MORGAN AND MORECAMBE OFFSHORE WIND FARMS: TRANSMISSION ASSETS

Technical Note: Landscape and Design Matters

Deadline: Deadline 3
7 July 2025

Document reference: S_D3_7

DRAWING TITLE
Figure 2: Cross Section of Morgan
Onshore Substation Site

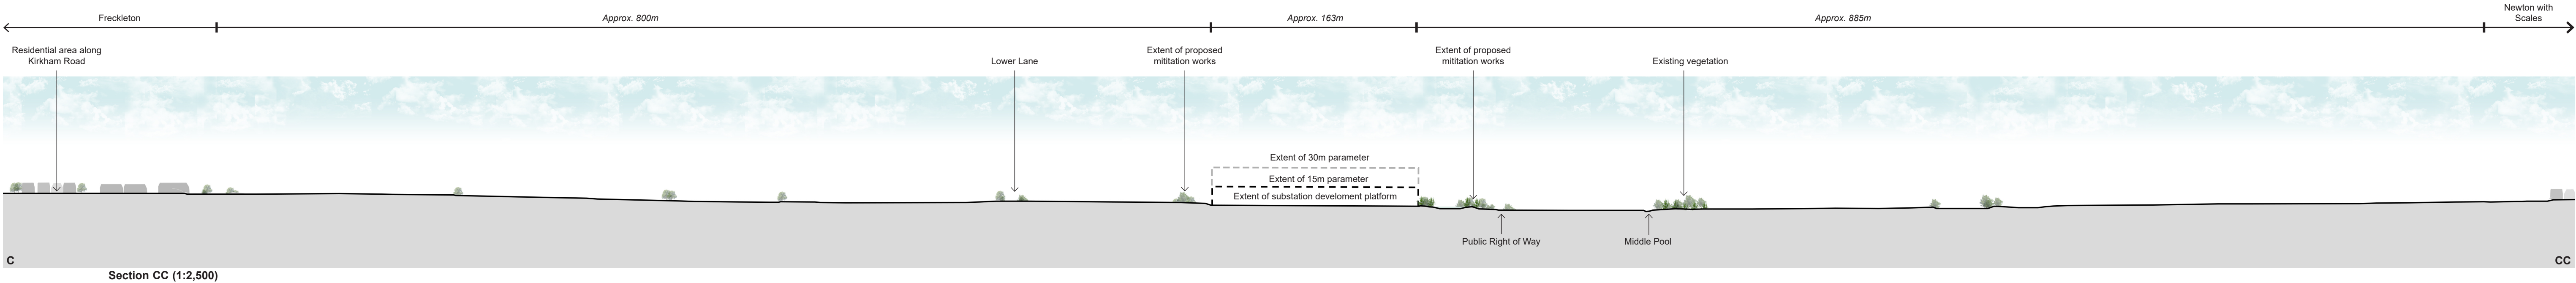
- 1.2.5.1 LCC LIR comments **REP1-085 7.61** and **7.86** notes a lack of detail regarding cut and fill operations associated with the substations, making it difficult to assess how the buildings will relate to the existing landscape levels. It specifically requests cross sections to show landform changes, which had not been provided as part of the DCO submission.

- **Figure 2: Cross Section of Morgan substation site**, and **Figure 3: Cross Section of Morecambe substation site** present long cross sections drawings through both the Morgan and Morecambe substation sites to supporting stakeholders understanding of the potential platform levels and development height parameters, and their relationship with the existing landform and nearest settlements.

- 1.2.5.2 The Applicants confirm that, in line with all offshore wind projects and their associated onshore transmission infrastructure, final substation layouts and levels will be determined at detailed design stage, informed by technical requirements. Cut and fill will be necessary to create level platforms, particularly at the sloping Morgan OWL site, and will be designed to minimise spoil movement, as described in the Project Description (REP2-008) and oLMP (AS-050). Detailed design, including levels, will be subject to approval by the relevant planning authority under Requirement 4 of the draft DCO (REP2-004).

- 1.2.5.3 The Applicants refer to the photomontages presented in Volume 3, Figures - Part 6 of 7 (F3.12/F02), and the maximum design parameters documented in Volume 3, Chapter 10 Landscape and visual resources (APP-123), in support of the LVIA undertaken and the resultant findings presented. The submitted visualisations represent the assessed worst-case development scenario and are based on accurately modelled 3D representations and assumed site levels, prepared in accordance with industry best practice.

Section B (1:500)

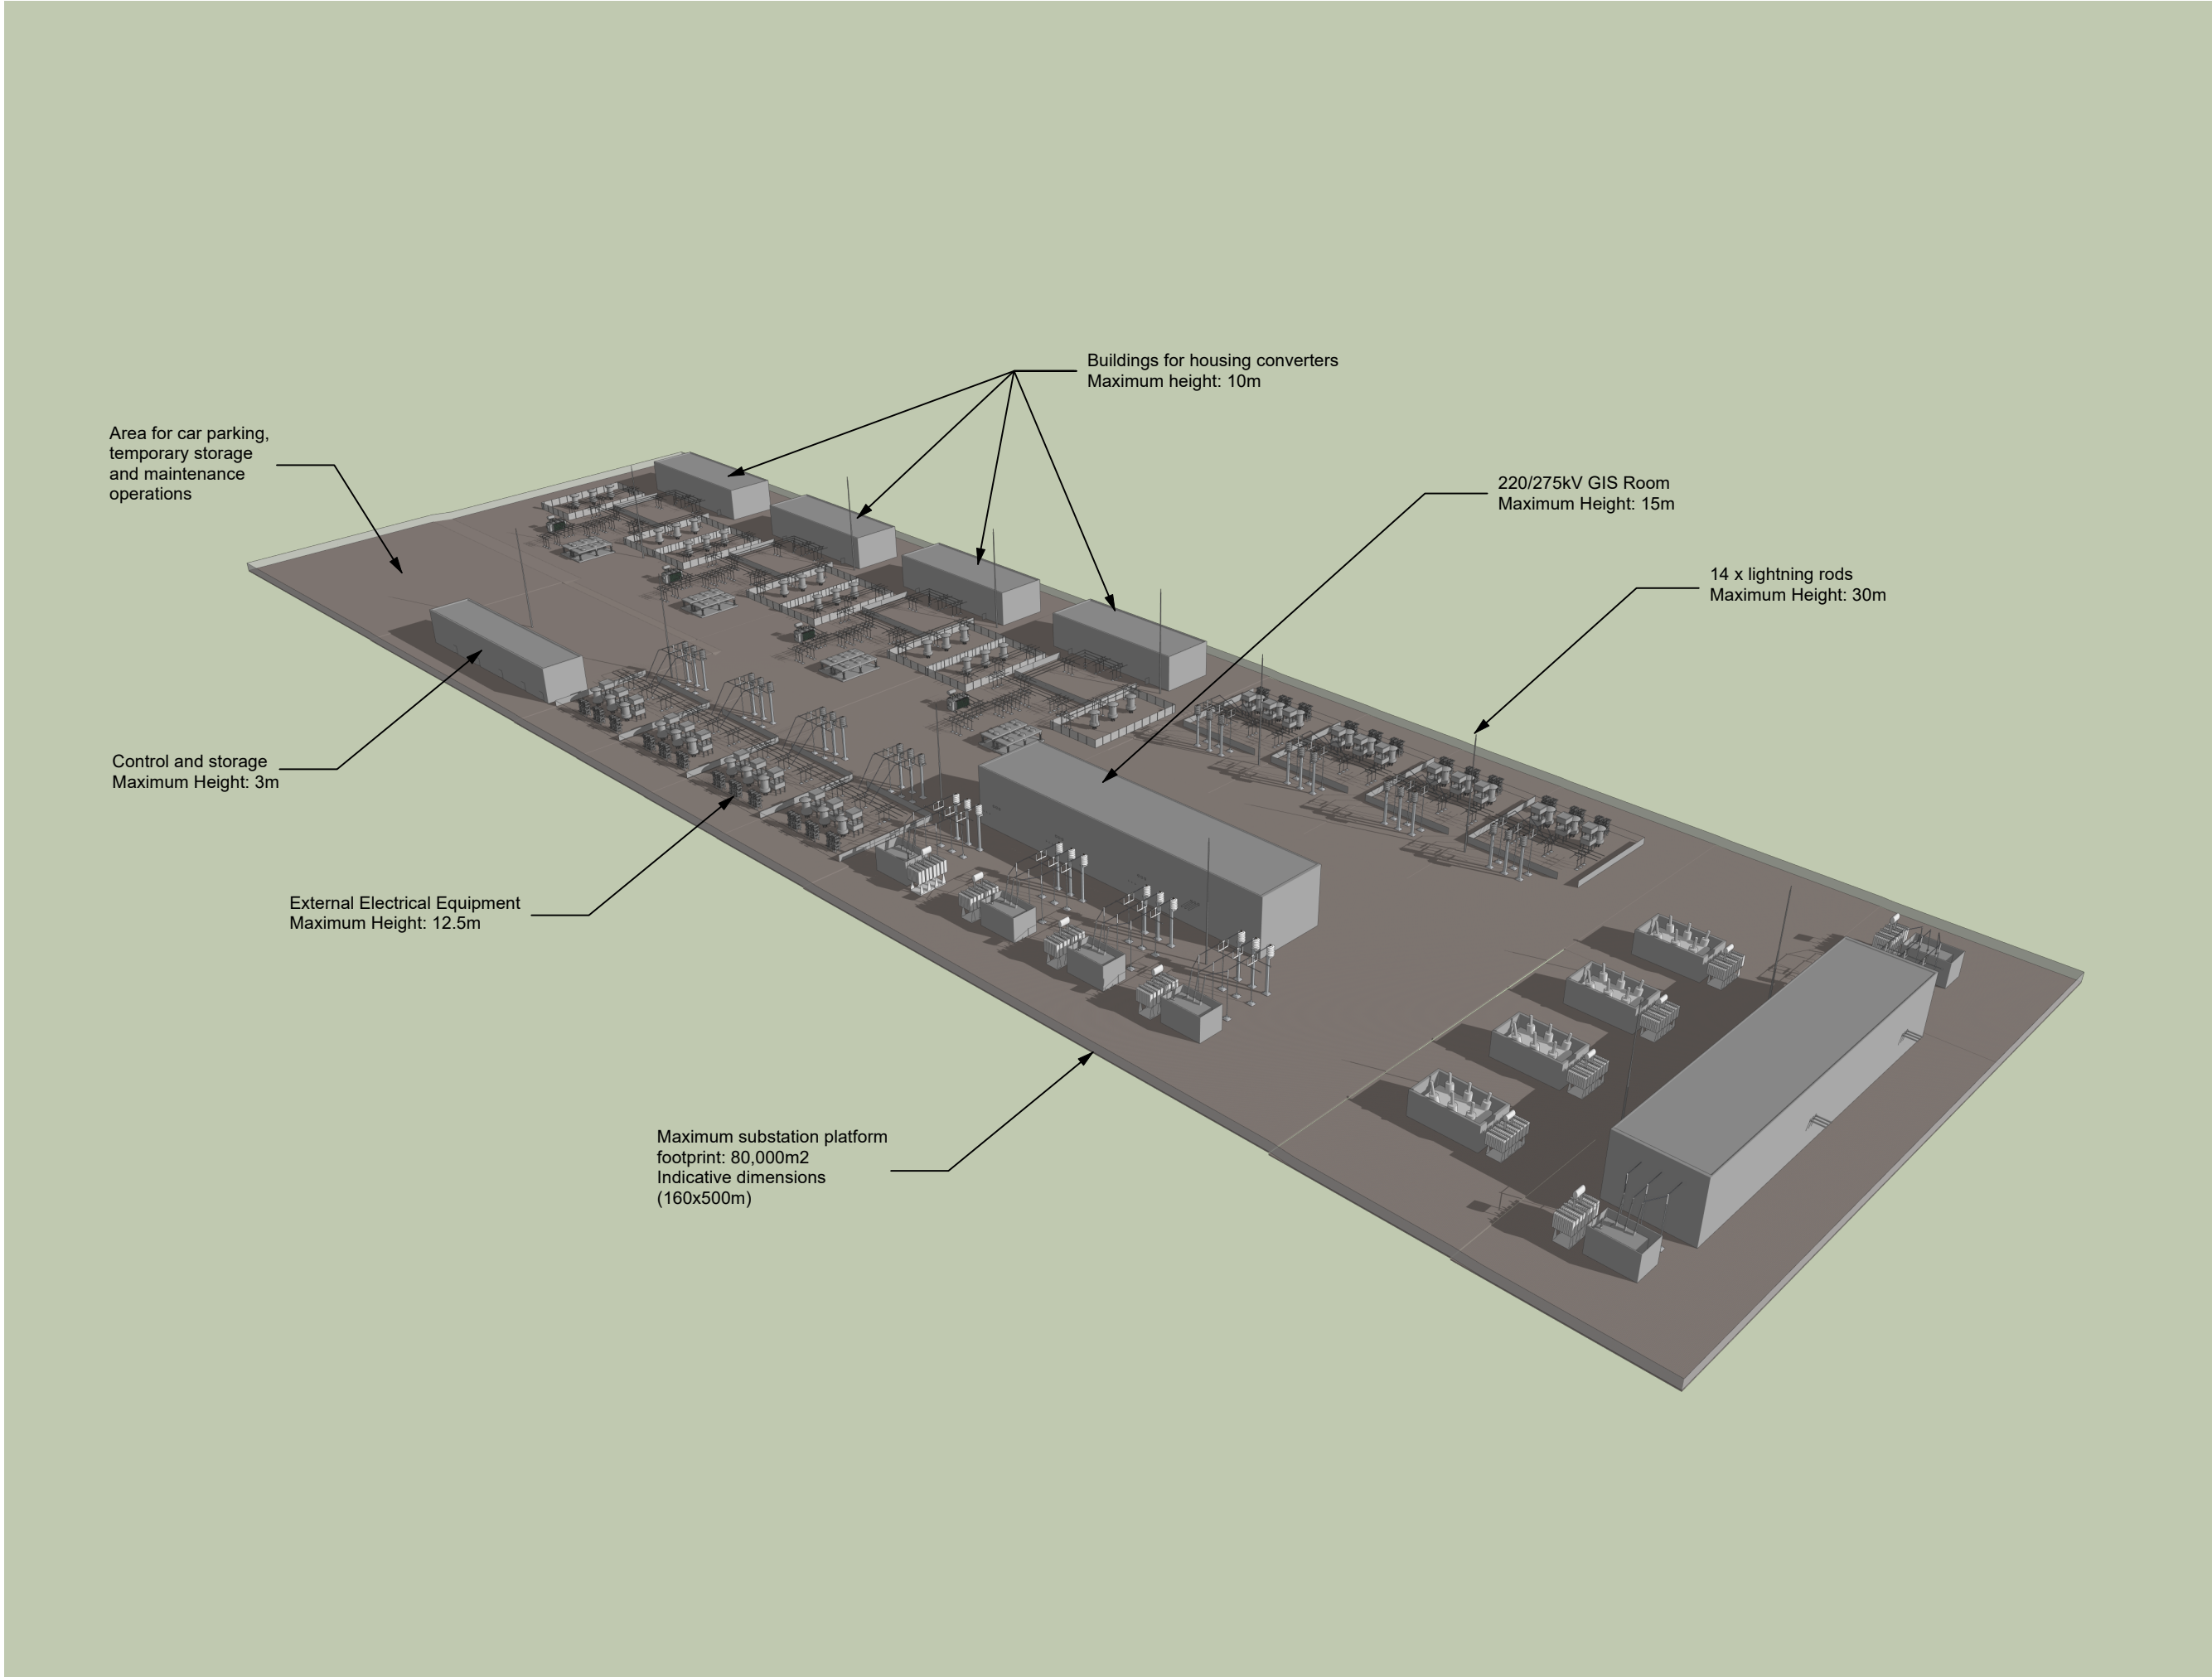
- 1.2.6.1 LCC LIR comment **REP1-085 7.70** suggests that the composition proposed for the woodland mix lacks sufficiently tall species to screen the substations effectively, especially on a receding slope (to the east of the Morgan substation down the Dow Brook). LCC suggests supplementing oak with taller species such as pine and beech, which are larger growing and may help filter views more effectively. LCC also note that birch is use as a nurse species and therefore will mean that numbers are reduced as climax species mature. LCC LIR comment **REP1-085 7.67** repeats that the scale of the proposed landscape mitigation is considered negligible in comparison to the scale of the substation buildings and recommends that mitigation measures should respond more closely to the local landscape character.

- 1.2.6.6 The appended figure — **Figure 4: Section through Morgan Substation** — provides an extract of the long cross-section in the vicinity of the Morgan substation, illustrating the indicative heights of the proposed woodland planting located to the east of the substation, on the receding slope down to Dow Brook, following 15 years of growth.

- 1.2.6.7 The cross-section assumes, as a conservative case, an annual growth rate of approximately 450 mm, with planting implemented at a minimum height of 450 mm. This assumption is based on IEMA guidance¹, which assumes and species performance under moderate conditions. It reflects typical early growth rates for native broadleaved species such as oak, birch and field maple, which range from 300 mm to 600 mm per year. This precautionary figure accounts for site-specific factors like soil quality and exposure and aligns with Forestry Commission publications and best practice in GLVIA3, which states: *“Assumptions about plant growth or other changes over time should be realistic and not over optimistic. The design concept for the mitigation has to have a good*

Figure 6

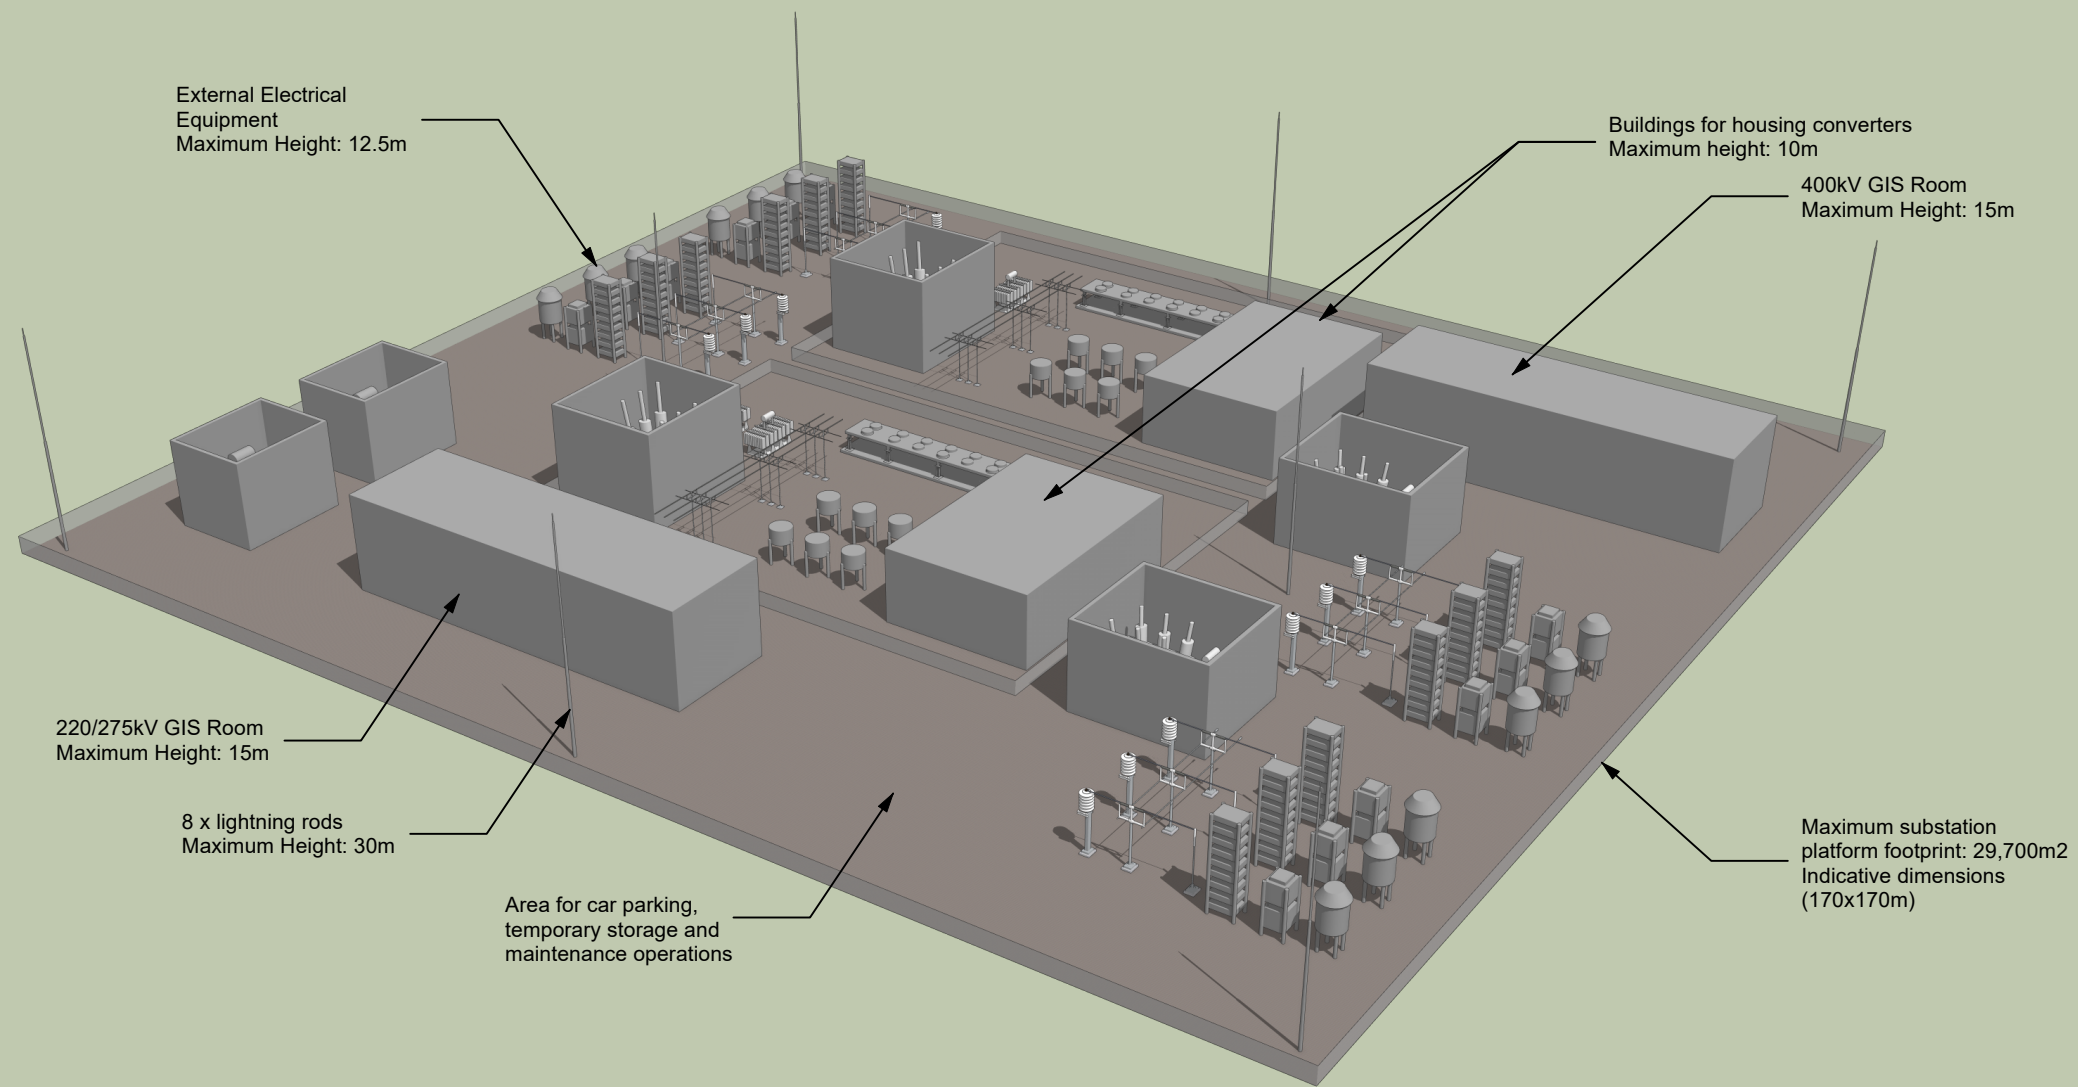
- 1.2.7.0 Q13.1.4 of the ExQ1 (PD-008) requests indicative layout drawings for each proposed substation, notating the different structures, equipment and buildings that would generally be required for each. This reflects stakeholder comments that state that there is limited information available.

- 1.2.7.1 As outlined in the Applicants' response to Q13.1.4, an indicative 3D illustration of each onshore substation site's layout has been prepared and is submitted for *Deadline 3*. This illustration annotates the typical

structures, equipment and buildings that would be required at each site, aligning with the EIA project description and the authorised development identified within the draft DCO. The layout mirrors the design used to prepare the photomontages.

- 1.2.7.2 This TN reaffirms that these layouts are indicative and intended for illustrative purposes only, and that the final design will be developed post consent and subject to the approval of the relevant planning authority in accordance with Requirement 4 in Schedules 2A and 2B of the draft DCO. Copies of the annotated indicative 3D layout of each onshore substation site are appended to this document in **A.1 Appendices as Figures 5 and 6**.
